Le Sueur County, MN

Board Meeting

RE: Le Sueur-Rice Joint Ditch 63

DATE: July 26th, 2018
TO: Darrell Pettis
FROM: Chuck Brandel
SUBJECT: SP 4010-10, TH99, County Ditch Culvert Work

TH 99
Crossing #1
CD 40
Le Sueur County,
Minnesota
Thursday, July 12, 2018

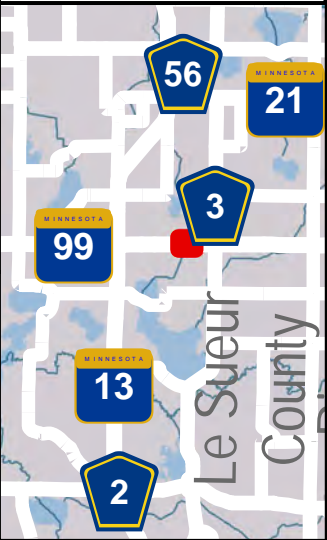
Crossing #1 (CD 40) has a current drainage coefficient of 2.88 in/day which is based on a slope of 1.28%. While the drainage coefficient is adequate the culvert is in poor condition, see Figure 1 below. The existing pipe has invert elevations of 1036.06 and 1035.20 Mean Sea Level (MSL) resulting in a 1.26% grade. The original profiles from the construction of the ditch in 1914 show a 0.02% grade. Utilizing survey information of the culverts taken by ISG upstream and downstream of the TH 99 crossing, and comparing these to original profiles, it has been determined that the CD 40 culvert was originally at an elevation of approximately 1038.95 MSL upstream and 1038.935 MSL downstream. Based on the roadway construction that will occur removing and replacing this culvert should be completed.

Crossing #1 (CD 40) is to be upsized to prevent the 50 year storm event from overtopping the road. Crossing #1 is proposed to be set at an inlet invert elevation of 1035.92 MSL and an outlet invert elevation of 1034.83 MSL resulting in a slope of 1.01%. This is similar to the existing 1.26% slope of the 84" culvert in place. The elevations of the proposed pipe are set slightly lower than existing elevations at about .15-feet and .4-feet. The original plans for this crossing showed a legal ditch grade set about 3-feet higher than the proposed and existing elevations of the culvert. The original crossing was set at about 1038.9 MSL with a slope of 0.02%.

ISG has reviewed MnDOT's plans for each of the culvert crossing under TH 99. MnDOT is proposing to replace two culvert crossings on County Ditch No. 40 as well as County Ditch No. 63. Both of the proposed culvert crossings have sufficient capacity. ISG recommends that the culvert crossing on County Ditch No. 40 have an upstream elevation of 1035.92 MSL and downstream elevation of 1034.83 MSL, resulting in MnDOT's proposed elevation and slope of 1.01%. This will allow the CD 40 culvert to increase capacity without drastically changing the elevation of the existing culvert, but it should be noted that the CD 40 culvert is well below legal grade elevation and set at a higher slope.

TH 99
Crossing #2
CD 63
Le Sueur County,
Minnesota
Thursday, July 26, 2018

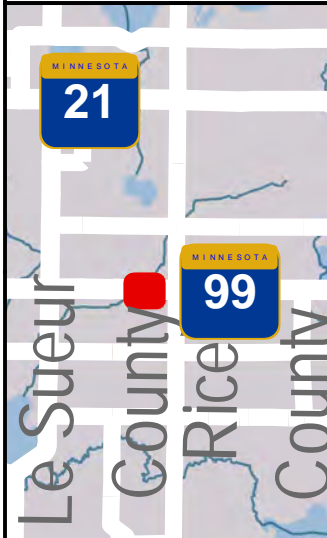
Crossing #2 (CD 63) has two 48" RCP culverts, one main culvert and one overflow culvert. The drainage coefficient for the main culvert is 1.70 in/day. The main culvert is in poor condition, see Figure 2 below. The current elevations of the existing main culvert are 1058.79 and 1058.21 MSL resulting in a 0.73% grade. The overflow culvert is set approximately 4 ft higher at a 0.18% grade with elevations of 1063.00 and 1062.04 MSL. The overflow culvert is in fair condition, but overgrown with vegetation, as can be seen in Figure 3. The original profiles show the culvert elevation to be approximately 1058.16 MSL downstream and 1058.24 MSL upstream with a slope of 0.10%.

Crossing #2 (CD 63) will be upsized to reduce the number of pipes that need to be maintained. In the 45% plans submitted by MnDOT the profile view for crossing #2 shows a 48" pipe as the proposed, but this will be a 60" pipe as reported in the excel review documents sent to ISG and will need to be updated in more complete plans. Crossing #2 (CD 63) is proposed to be set at an inlet invert elevation of 1059.0 MSL and an outlet invert of 1057.86 MSL resulting in a slope of 0.96%. This is slightly higher than the existing 0.73% grade, and much higher than the original plans grade of 0.10%. However, the elevation is set nearly at original elevation of the originally constructed open ditch.

Based on the elevations of the CD 63 TH 99 crossing and the crossing at 141st Ave, the crossing on Jim Fishers land is at the correct slope, with sufficient drainage capacity at 1.10in/day. However due to the TH 99 culvert capacity being larger at 2.88in/day, Mr. Fisher contends that his land floods and his crossing has less capacity than the TH 99 crossing upstream and the crossing at 141st Avenue downstream. The TH 99 culvert shall be placed at a slope of 0.05% with a 60" culvert or the culvert on Mr. Fisher's land should be replaced with the project. The current proposed capacity of 4.77in/day will increase the potential of flooding downstream. ISG recommends that the culvert crossing on County Ditch No. 63 have an upstream elevation of 1057.52 MSL and downstream elevation of 1057.47 MSL at 0.05%. This will set the CD 63 culvert inlet at legal grade elevation while maintaining the proposed capacity of the crossing.

**Driveway Crossing
CD 63**
Le Sueur County,
Minnesota
Thursday, July 26, 2018

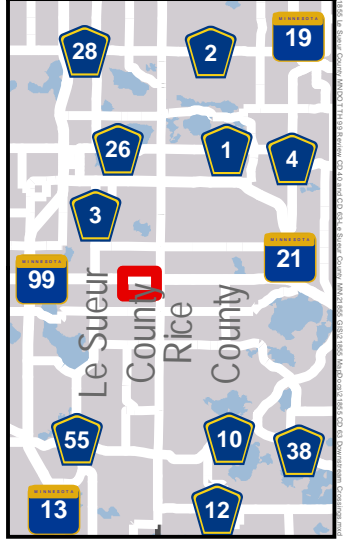
On request of a downstream landowner, Mr. Jim Fisher, two culverts downstream of CD 63 located in Section 36 of Montgomery Township were observed. The landowner has stated that his land has experienced flooding has overtopped his driveway several times in the last 10 years, therefore the culverts were checked for sufficient capacity and existing conditions. Table 2 shows the existing culvert capacities. Figure 4 shows the ditch condition just upstream, and just downstream of the driveway crossing.

ISG proposes 3 options for the culvert crossing Jim Fishers driveway to address the flooding caused by rain events. These options are shown below in Table 4. Option 1 is to replace the existing 60" CMP with a 60" RCP to increase the capacity to be closer to the capacity of the upstream CD 63 TH 99 culvert and the downstream 141st Ave culvert. Option 2 is to replace the existing 60" CMP with a 72" CMP. Option 3 is to match the proposed CD 63 Th 99 crossing to the existing capacity of the driveway crossing. This would reduce the occurrence of flooding on Jim Fishers land due to a lower drainage capacity.
